Address of the Project: **431 Pittwater Road, North Manly**

Description of Project: **Engineering Referral Response - DA2023/1708**

STORM-2/A

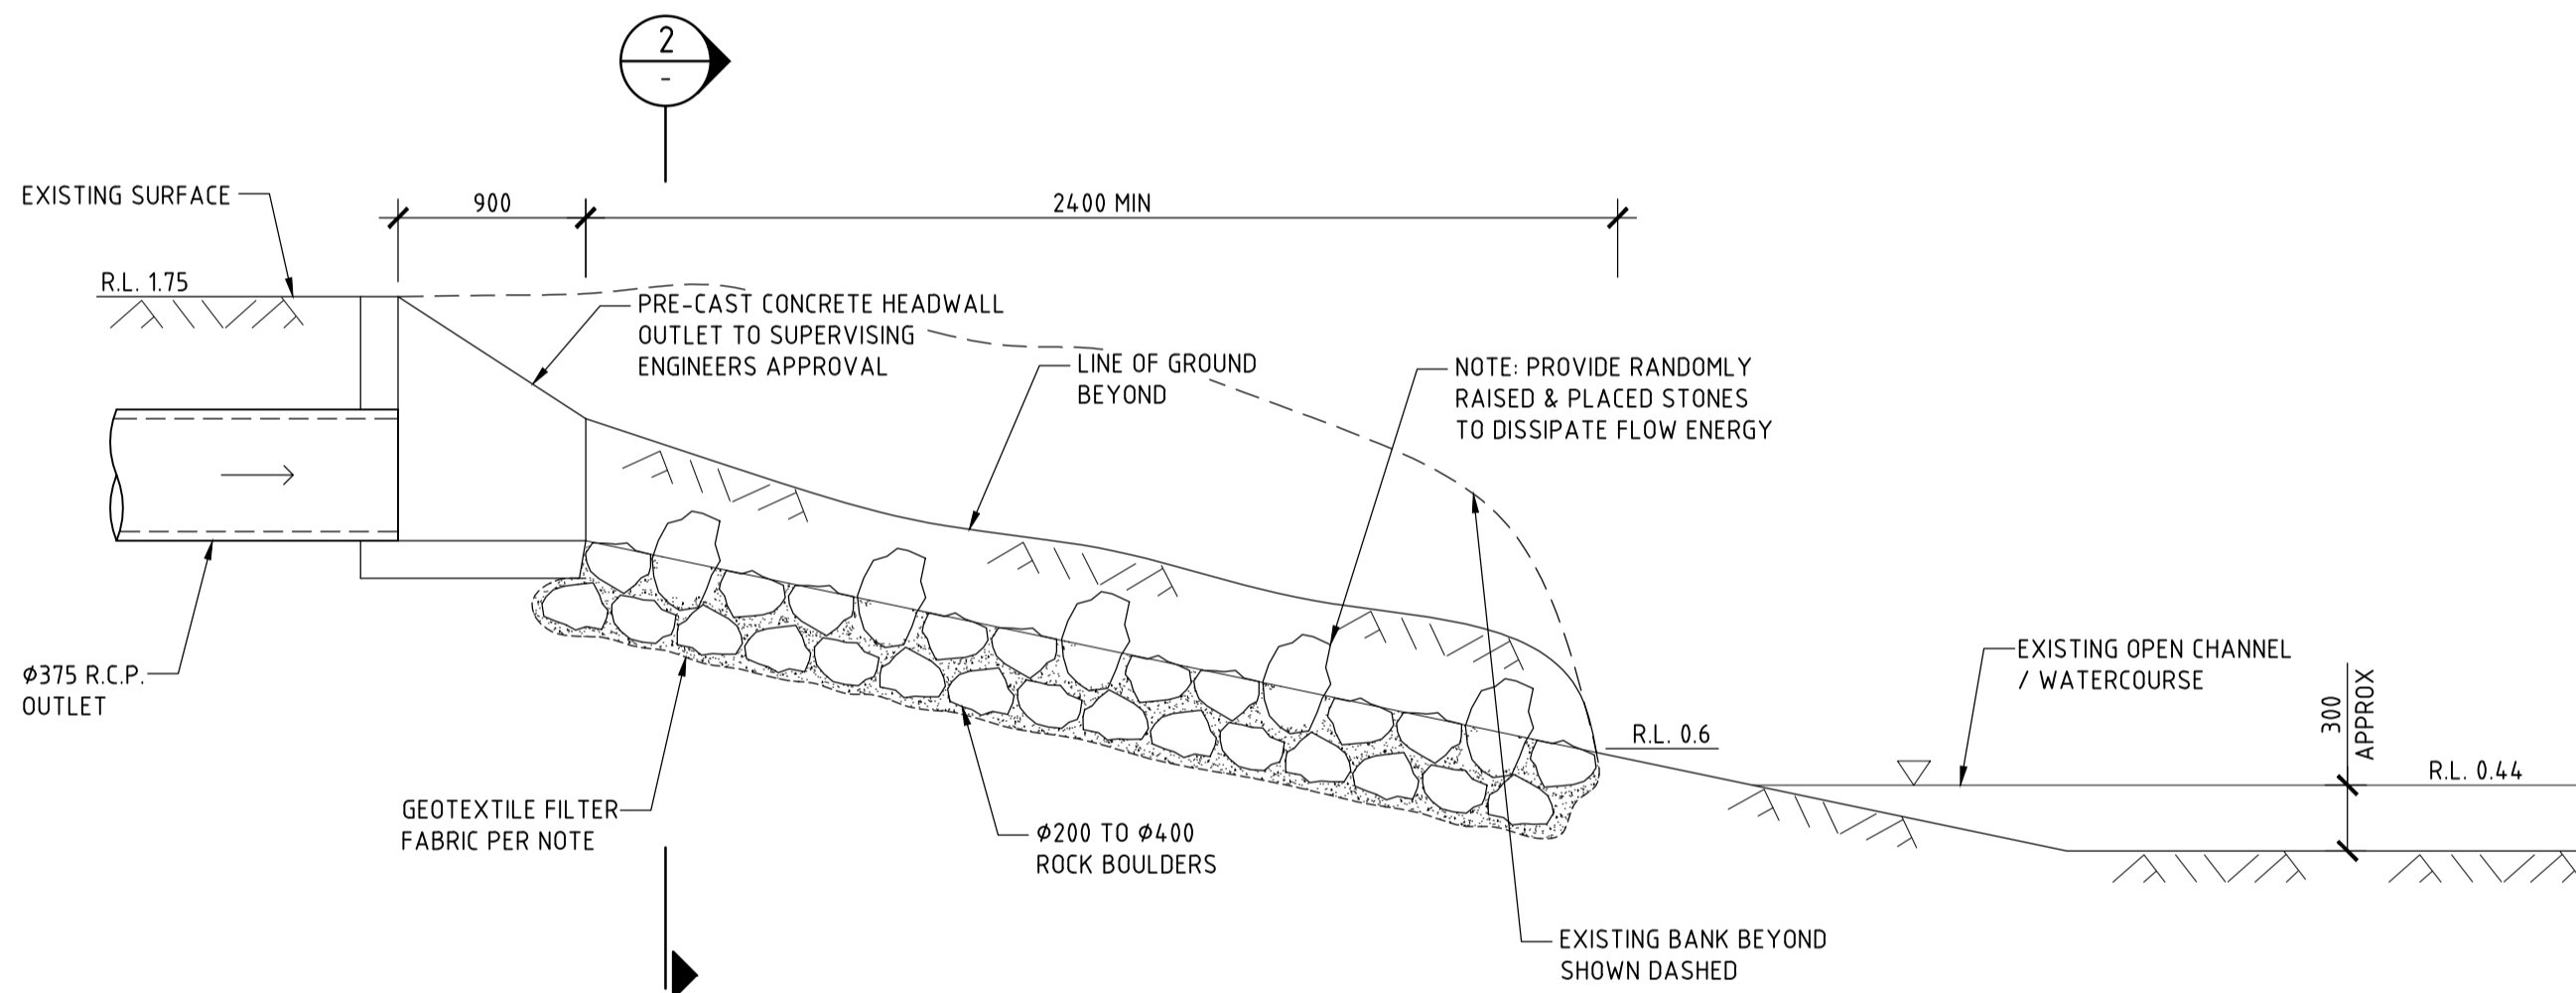
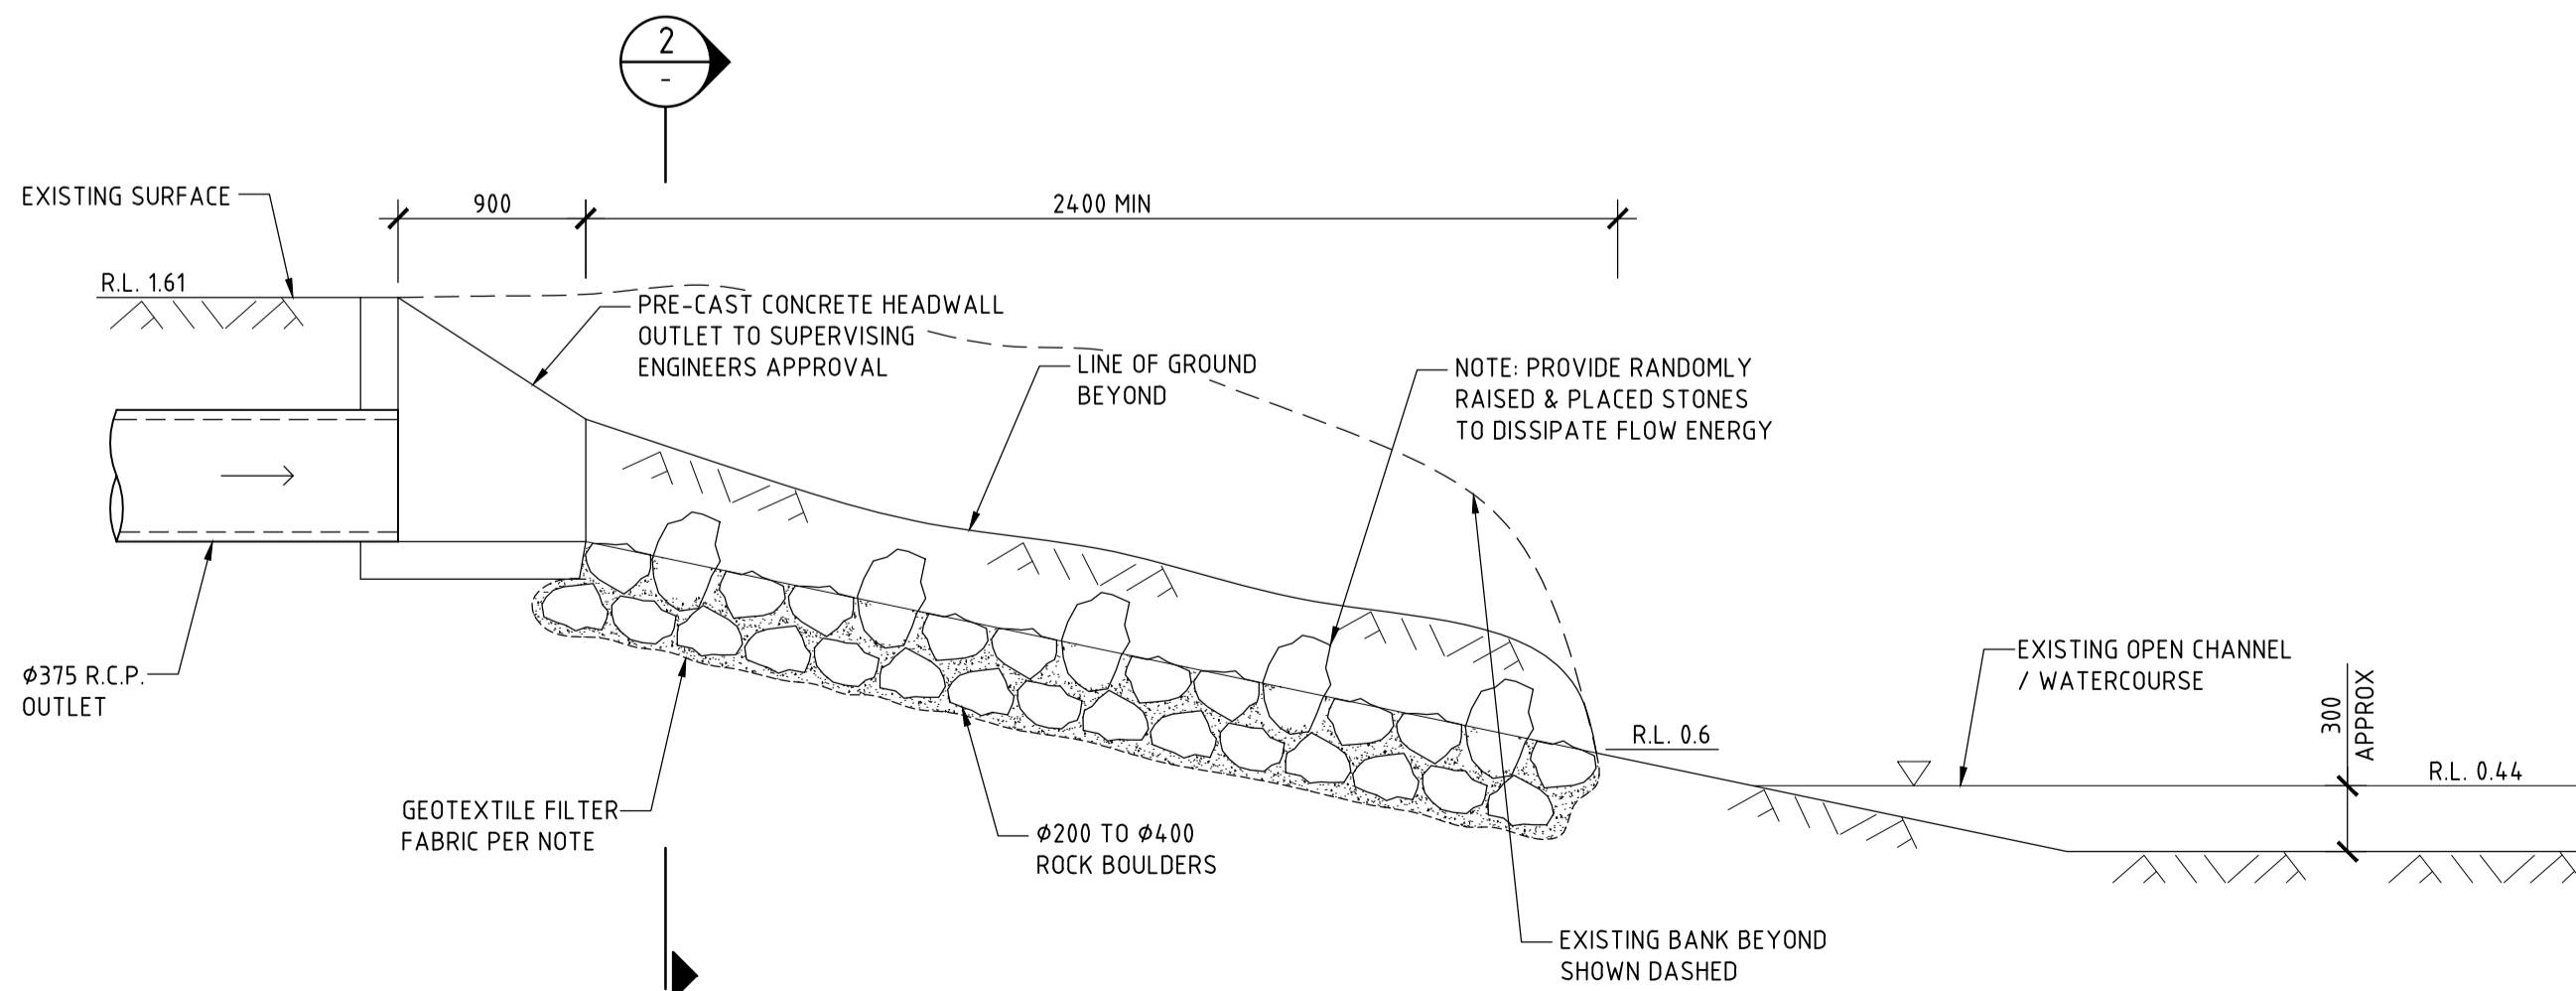
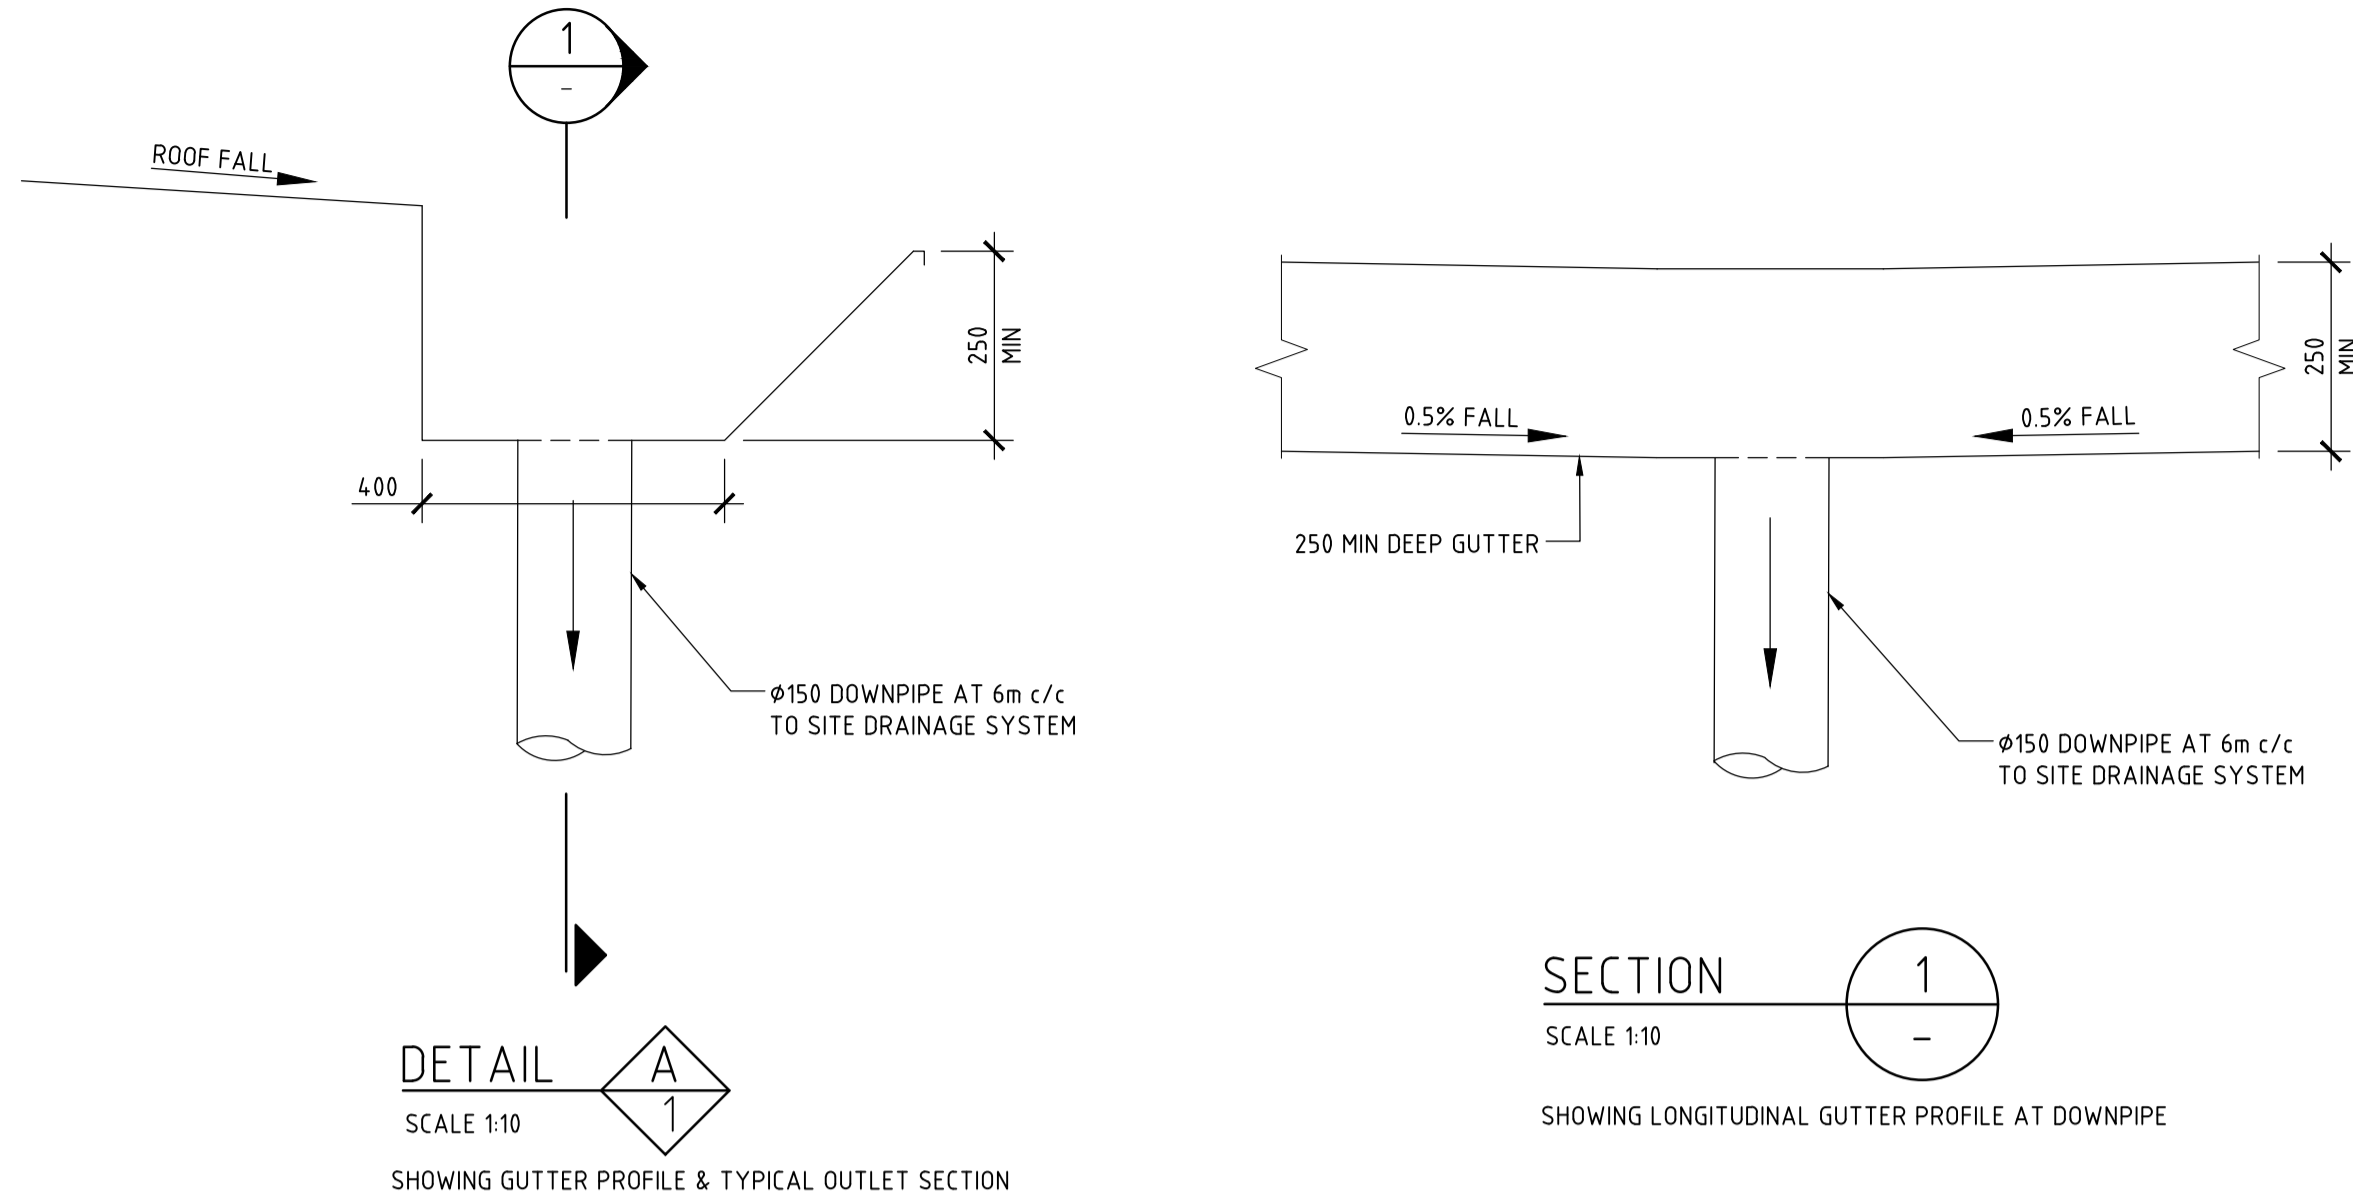
1. Outlet cross-section with relevant outlet and creek levels

- The Stormwater Management Plan has been updated with additional topographic levels to show the existing creek bed & water surface levels (Refer to STORM-1/A & STORM-2/A attached).
- Headwall outlet & scour protection detail has been updated to show proposed outlet levels (Refer to STORM-2/A attached).
